Report on submissions and further submissions on the
Proposed Waikato District Plan

Hearing 27D: Coastal Hazards

Response to Submissions on Waikato District Plan Stage 2: Coastal Hazard Area Maps (March 2021). Prepared by Bronwen Gibberd 4D Environmental Ltd and Jim Dahm Eco Nomos Ltd

**Response to Submissions on Waikato
District Plan Stage 2:
Coastal Hazard Area Maps**

Figure 35: The extent of the Coastal Sensitivity Area (Inundation) overlay at 25 Robertson Street.

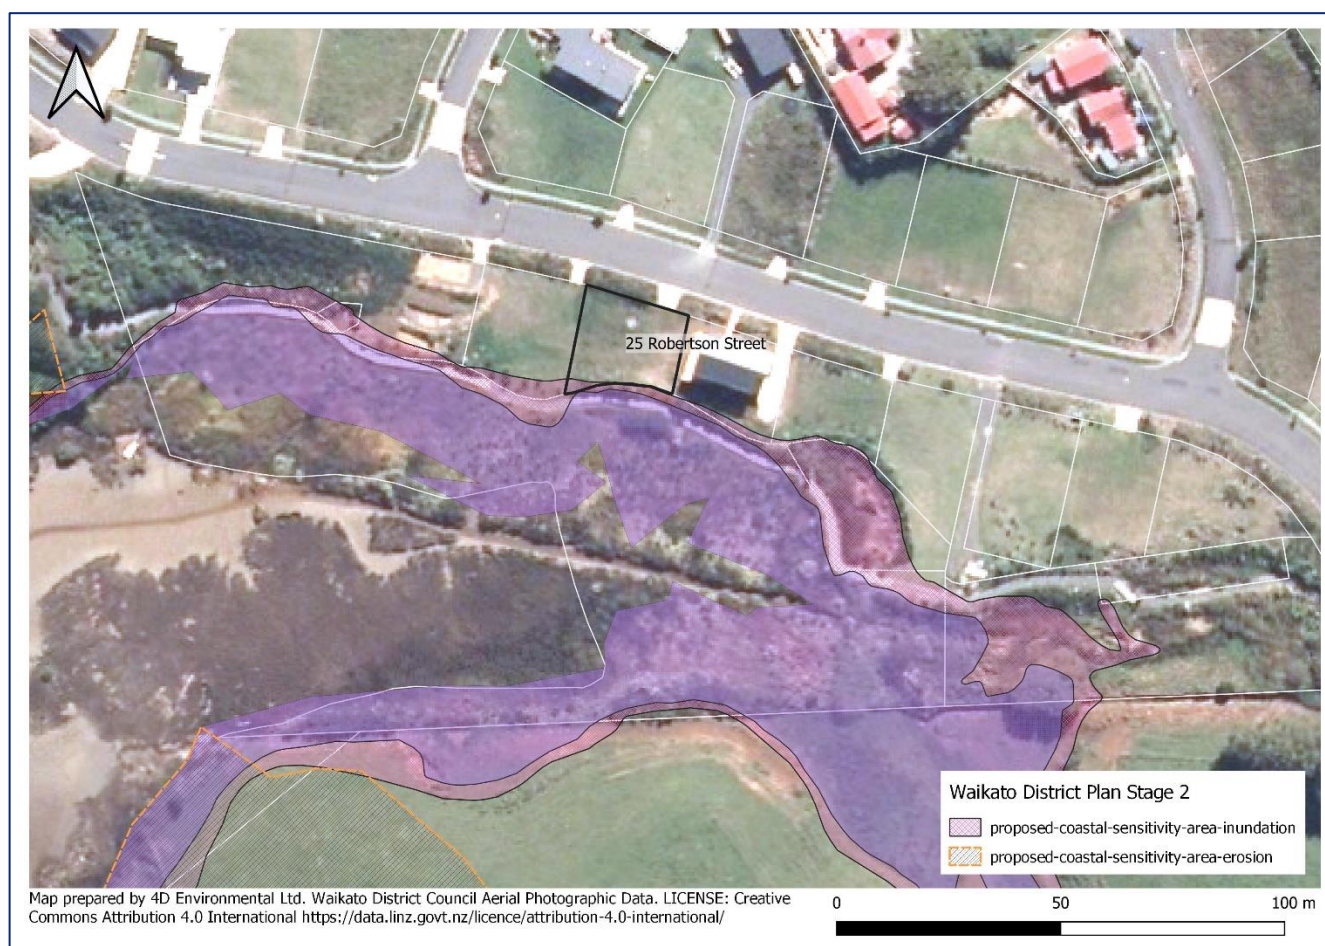
Discussion: The property at 25 Roberston Street is located adjacent to Kaitoke Creek, on the southern shore of Raglan Town. The property lies below the road and is fronted by a coastal wetland reserve. The Coastal Sensitivity Area (Inundation) overlaps a very small area of the most seaward edge of the property (Figure 35). Review of the elevation data confirms that the most seaward edge of the property is below 4.0 m (MVD-53) and is therefore correctly included in the Coastal Sensitivity Area (Inundation). The property slopes upwards to approximately 8.5 m (MVD-53) at the road boundary. Almost all of the property is elevated well above current extreme storm tide levels and will remain above expected coastal inundation levels after 1.0 m of sea level rise.

Recommendation: We recommend retaining the Coastal Sensitivity Area (Inundation) as notified.

Figure 37: Cross section at 9 Tohoro Close, Whale Bay. Blue line and arrow illustrates definition of High Risk Coastal Hazard Area (Erosion), orange line and arrow indicates definition of Coastal Sensitivity Area (Erosion).

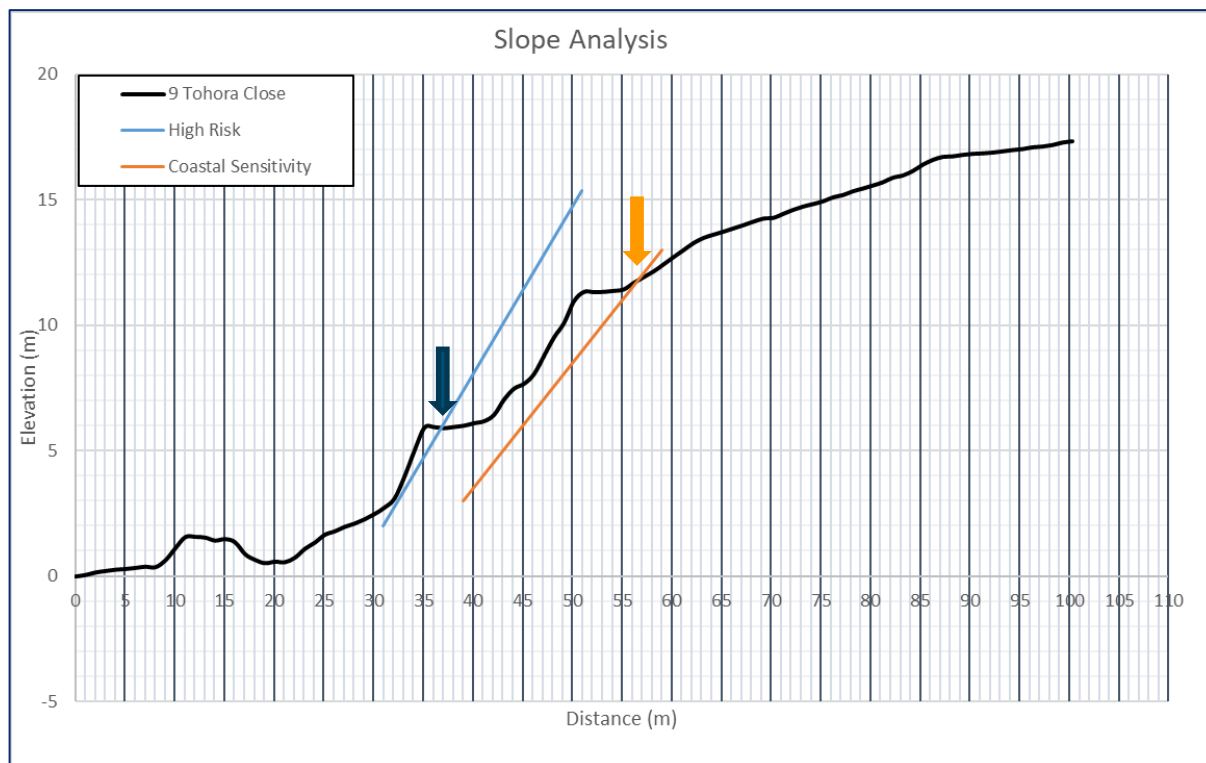
A further field visit was completed, and a meeting held with the property owner of 9 Tohoro Close. The calculations and profile shape at 9 Tohoro Place were checked and it was confirmed the mapping could not be further refined using the current methods.

Recommendation: The current proposed Coastal Sensitivity Area (Erosion) cannot be revised further without more detailed geotechnical investigations to determine the depth and physical characteristics of terrace deposits and the depth of volcanic materials underneath the surface.

Figure 38: Proposed Coastal Sensitivity Area (Open Coast) at 536 Wainui Road.

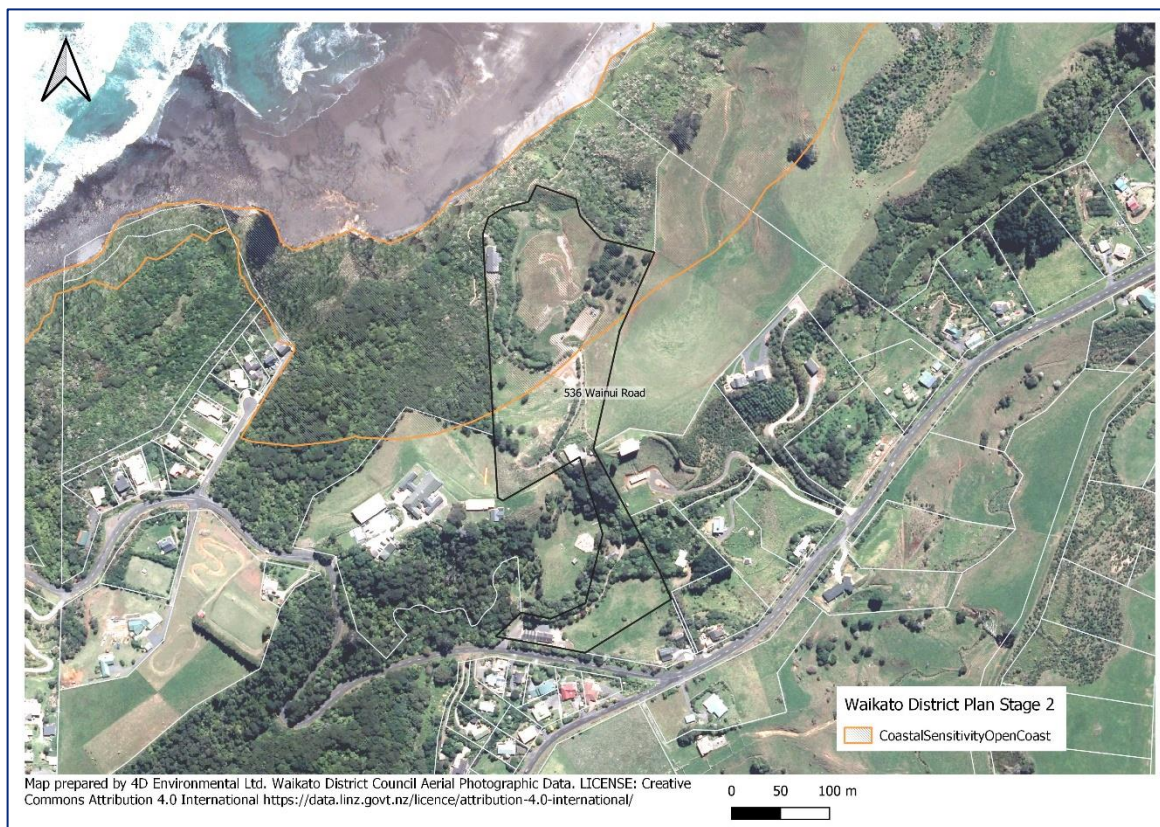
The property in question is located at the southern end of Ngarunui Beach (Figure 38). The coastline is backed by steep vegetated slopes (approximately 30-45 m high), with gradients of approximately 1V:1H in the vicinity of 536 Wainui Road (Figure 39). Further north on Ngarunui Beach, active modern sand dunes separate the beach from the cliffs. There are currently no sand dunes at the southern end of the beach, where there appears to be slow erosion of cliff toe. An existing dwelling on the property is located at the top of the coastal cliff, approximately 100 m landward from the beach. This area is within the proposed 200 m wide Coastal Sensitivity Area (Open Coast).

The 200 m wide Coastal Sensitivity Area (Open Coast) has been defined with sufficient width to encompass potential long term coastal erosion hazard along the rural open coast of the Waikato District. This width needs

Figure 41: Horongarara Point (Te Akau south) area for revised coastal sensitivity assessment). Properties edged with black indicate submissions received.

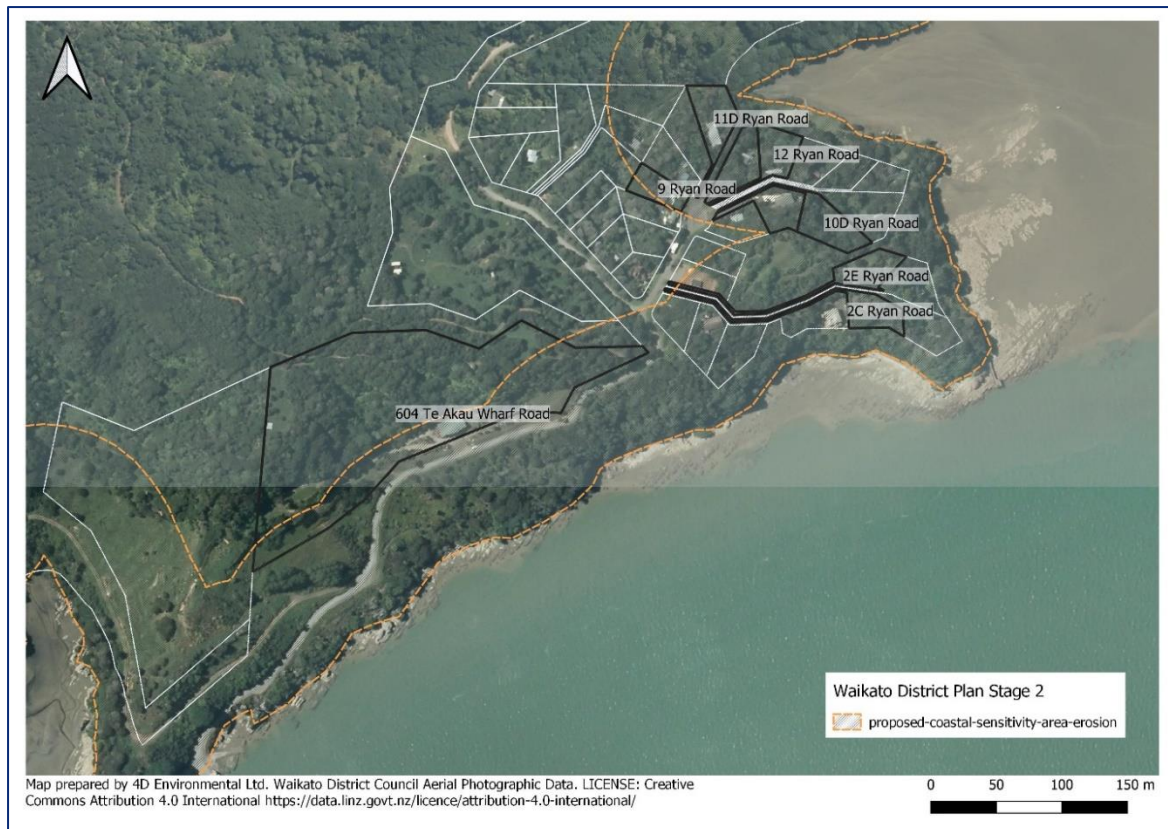
During notification of the proposed Plan, submissions were received from property owners in this area highlighting the need for a site-specific investigation to define coastal erosion hazard. Given the higher intensity of development and Village zoning, it is appropriate to consider likely coastal erosion hazard in more detail. As part of the response to submissions, Council therefore commissioned a more detailed assessment of coastal erosion hazard in this area.

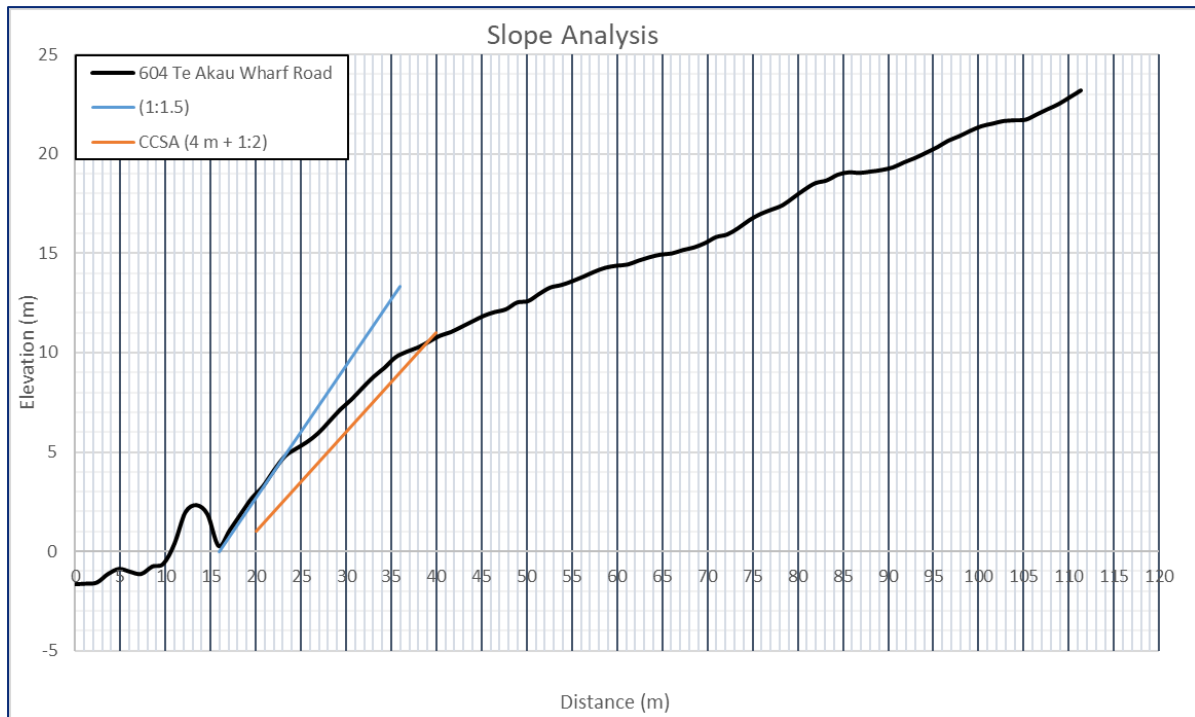
The primary cause of erosion appears to be slow weathering processes (e.g. salt weathering, wetting and drying) acting on the rock surface with wave removal of the weathered debris. Accordingly, we would expect limited erosion of this hard material over planning timeframes, shoreline retreat likely averaging in the order of 1.0 m per century or less. This assessment is also supported by the narrow shore platform. Sea level rise may accentuate the erosion processes but is not likely to lead to excessive rates given the nature of the geology and the erosion processes operating at this site. We believe a doubling of toe erosion rates to 2.0 m per century will provide adequate allowance for any change.

We also recommend a Coastal Sensitivity Area (Erosion)⁴ that incorporates 2 m of toe erosion and a conservative 1V:2H stable slope. This conservative slope has been applied throughout the study area and reflects the lack of detailed information about the nature and structure of the sub-surface materials. The area overlain by the revised Coastal Sensitivity Area (Erosion) is predominantly coastal reserve (Figure 46). However, the high steep slopes at the eastern end of the 604 Te Akau Wharf Road property result in a wider Coastal Sensitivity Area (Erosion) at this location, which extends across the road and into the property.

Figure 48: Typical cross section in Section 2.

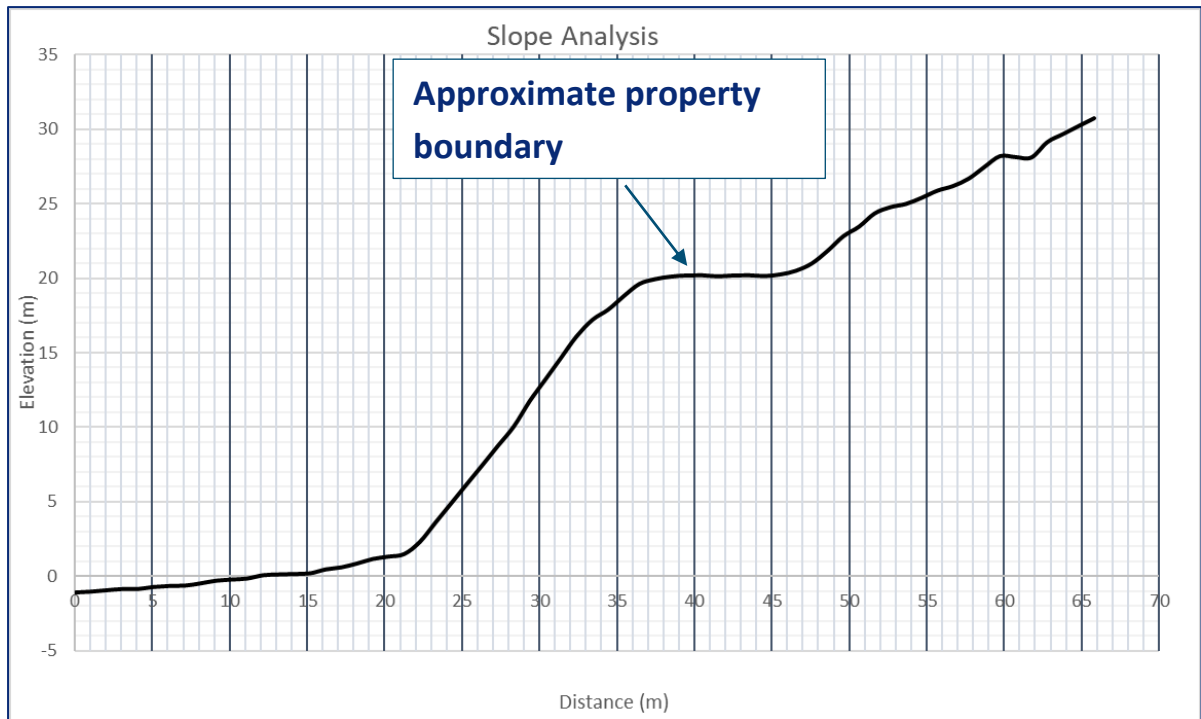
This section of the shoreline is separated from Section 1 (Limestone) at the location of a known fault, where the geology at the shoreline changes. Materials exposed at the shoreline are varied but the area is broadly characterised by high siltstone cliffs (Figure 47) and a shore platform 30-60 m wide. The grey-white calcareous siltstone cliffs show evidence of recent slope failure in places. Where exposed, the siltstone is weathering and fracturing to pebble sized material through to small and large boulders. Typical cliff slopes in this area are 1V:1H and in some places are near vertical (Figure 48).

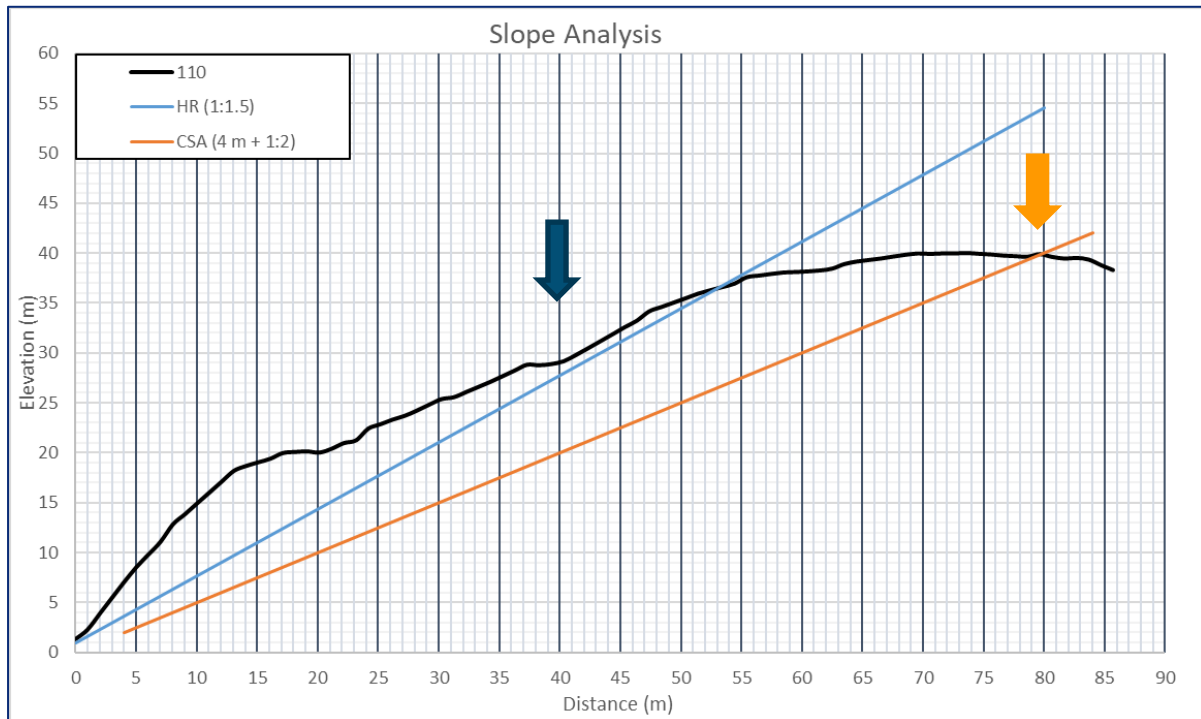
The revised coastal hazard and sensitivity areas vary in width from 20-60 m width (High Risk Coastal Hazard) and 30-80 m (Coastal Sensitivity) depending on the elevation and slope of the coastal margin (Figure 12). The area is widest where the coast is backed by high steep slopes at 2a and 2c Ryan Road and 585 Te Akau Wharf Road.

define coastal erosion hazard. However, this would need to be determined by a site-specific study by a suitably qualified engineering geologist or geotechnical engineer, in the context of any proposed activity.

Figure 54: Cross shore profile in the vicinity of the recent land slip (elevation data pre-dates the landslip). Blue and orange arrows indicate the landward boundary of the High Risk Coastal Hazard Area (Erosion) and Coastal Sensitivity Area (Erosion) respectively.

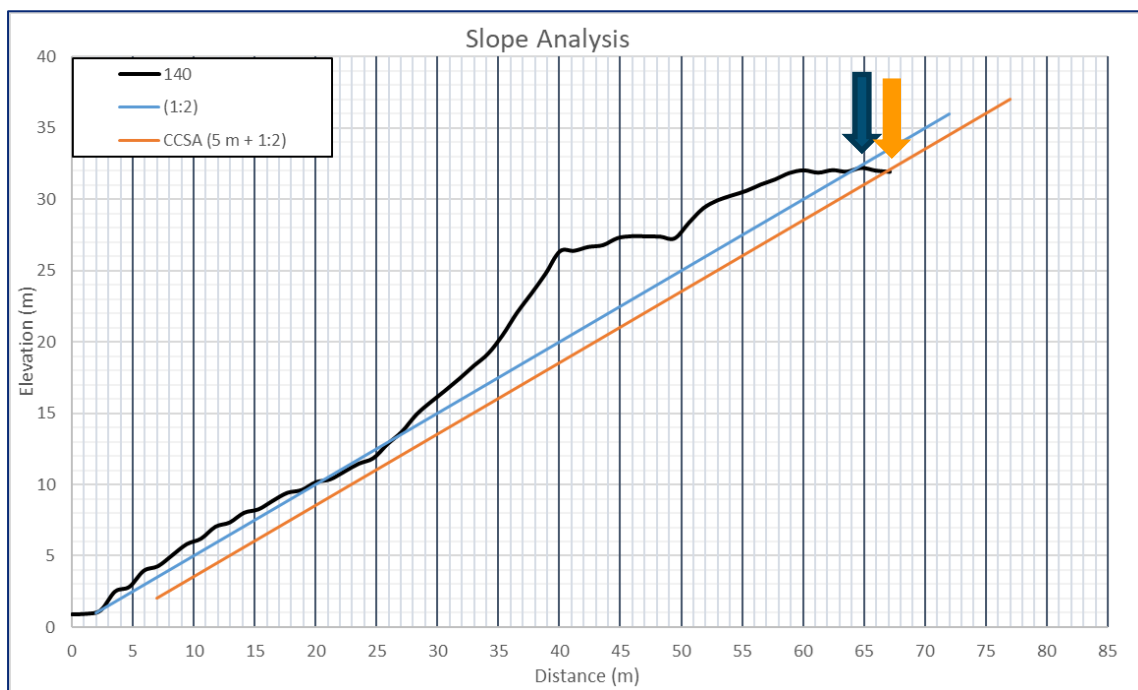
Cliff slopes in the headland areas at either end vary from 1V:1H to 1V:1.5H but more gentle slopes (typically 1V:1.5H to 1V:2H) are noted in some central areas. A deep-seated landslide was observed on this shoreline fronting 2e Ryan Road (Figure 53). This failure is only 2-3 years old, so occurred since the land elevation data used for his study was collected (2015). Slopes may therefore vary slightly from those measured and reported in this area. Cracks developing on the upper slopes above steep areas near the north end of the Bay indicate further slope failures are likely to occur.

Given the complex shoreline and evidence of ongoing active slope failures, we recommend that the High Risk Coastal Hazard Area (Erosion) be defined by a 1V:2H stable slope in the more gently sloping areas (e.g. Figure 54). At locations fronted by steep siltstone cliffs, a slope of 1V:1.5H is appropriate, as applied in Section 2 (Figure 55). The highly varied nature of the shoreline makes slope-based mapping complex, and we have also applied minimum width of 20 m and 30 m to the High Risk Coastal Hazard Area (Erosion) and Coastal Sensitivity Area (Erosion) respectively, measured from the toe of the cliff.

Figure 58: Revised High Risk Coastal Hazard Area (Erosion) and Coastal Sensitivity Area (Erosion) at Te Akau South (Section 4).

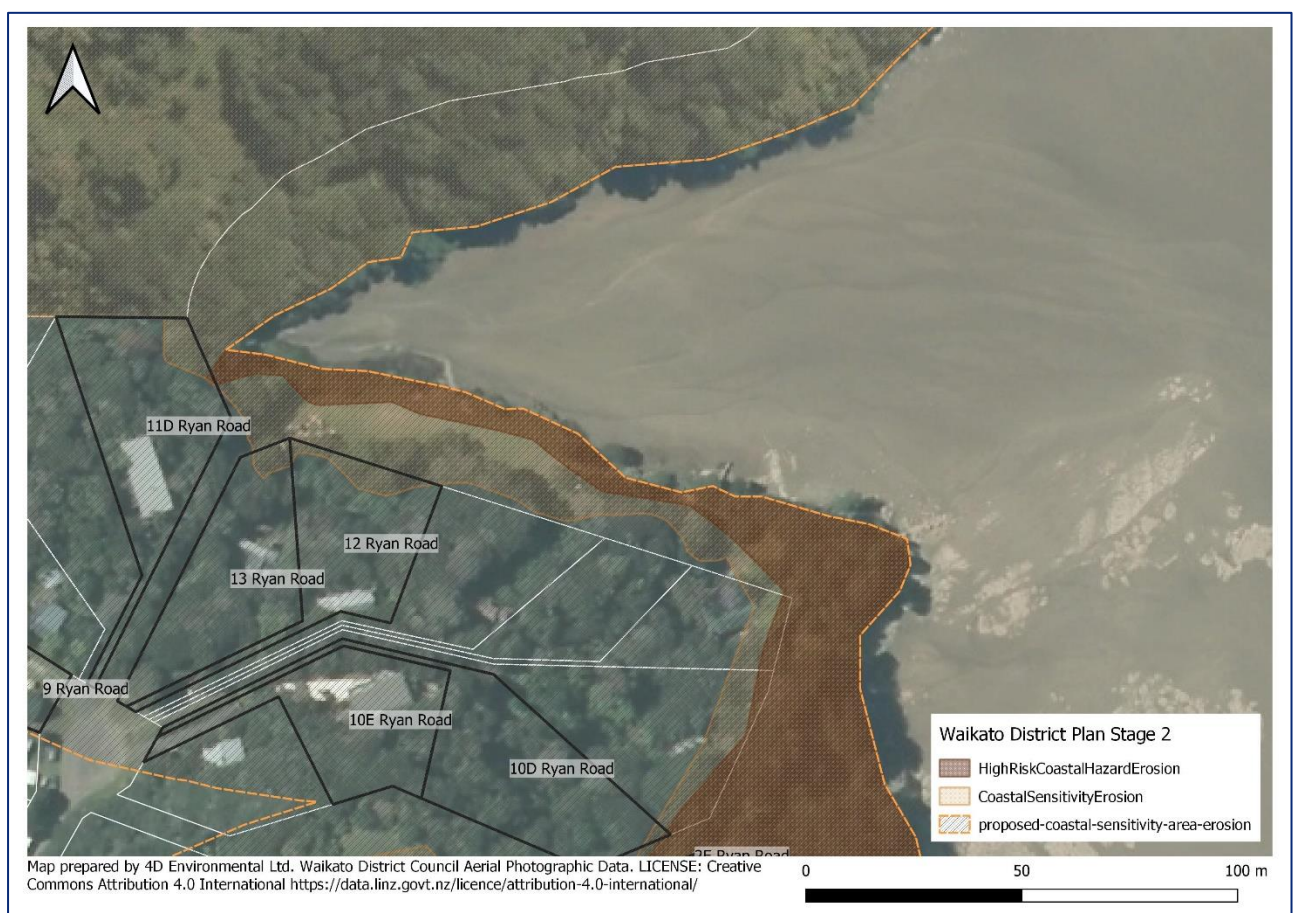
Section 4 is backed mostly by a low-lying grassed reserve up to 20 m wide (Figure 57). Residential sections are located on the elevated slopes to landward. During the site visit, it was noted by residents that there has been some minor erosion of the frontage over time. Works have been undertaken to stabilise and revegetate some areas. This area is relatively sheltered from wave action. The seaward edge of the reserve is relatively low lying (RL 2-3 m), so is potentially susceptible to occasional coastal inundation during extreme events.

We recommend that the 100 m Coastal Sensitivity Area (Erosion) be amended here to produce a High Risk Coastal Hazard Area (Erosion) and a Coastal Sensitivity Area (Erosion) based on a pragmatic approach that reflects the local setting (Figure 58).
